Access Compliance Report Public Rights-of-Way (Curb Ramps)

Intersection ID: 47833 Main Street: TOM_SHORT_RD Cross Street: SPUR_RANCH_RD Location: N

ADA ID: 3AB488A3B1F4 Ramp Type: PerpDiag Initial Pass/Fail: Fail Overall Compliance: No Severity Score: 8.75

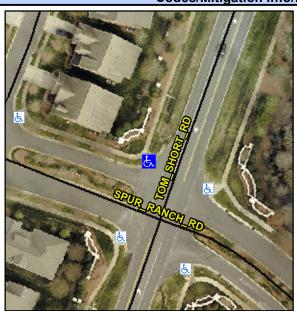
Not Found, R304.5.1

Field Measurements/Component Compliance						
	Compliance Description		Data	Compliance Description		Data
	N/A	Ramp Length (in)	106.0	Yes	Ramp Slope (%)	5.9
	No	Ramp Width (in)	45.0	Yes	Ramp XSlope (%)	0.5
	N/A	Flare Type LT	N/A	N/A	Flare Type RT	N/A
	N/A	Flare Slope LT (%)	N/A	N/A	Flare Slope RT (%)	N/A
	N/A	Flare Traversable LT?	N/A	N/A	Flare Traversable RT?	N/A
	N/A	Landing Length (in)	N/A	N/A	DWS Provided?	N/A
	N/A	Landing Width (in)	N/A	N/A	DWS Contrast?	N/A
	N/A	Landing Slope (%)	N/A	N/A	DWS Length (in)	N/A
	N/A	Landing X Slope (%)	N/A	N/A	DWS Full Width?	N/A
	N/A	Landing Curb? (Y/N)	N/A	N/A	DWS Offset (in)	N/A
	N/A	Shared Landing?	N/A			
	N/A	Gutter Ponding?	N/A	N/A	Gutter Slope (%)	N/A
	N/A	Gutter Lip Ht (in)	N/A	N/A	Gutter X Slope (%)	N/A
	N/A	Painted X Walk1?	No	N/A	Painted X Walk2?	No
		X Walk 1 Direction	To SW		X Walk 2 Direction	To SE
	N/A	X Walk 1 Width (in)	N/A	N/A	X Walk 2 Width (in)	N/A
		X Walk 1 Slope (%)	0.7		X Walk 2 Slope (%)	3.2

Remove & Replace Curb Ramp With
Two New Directional Ramps or
Equivalent.
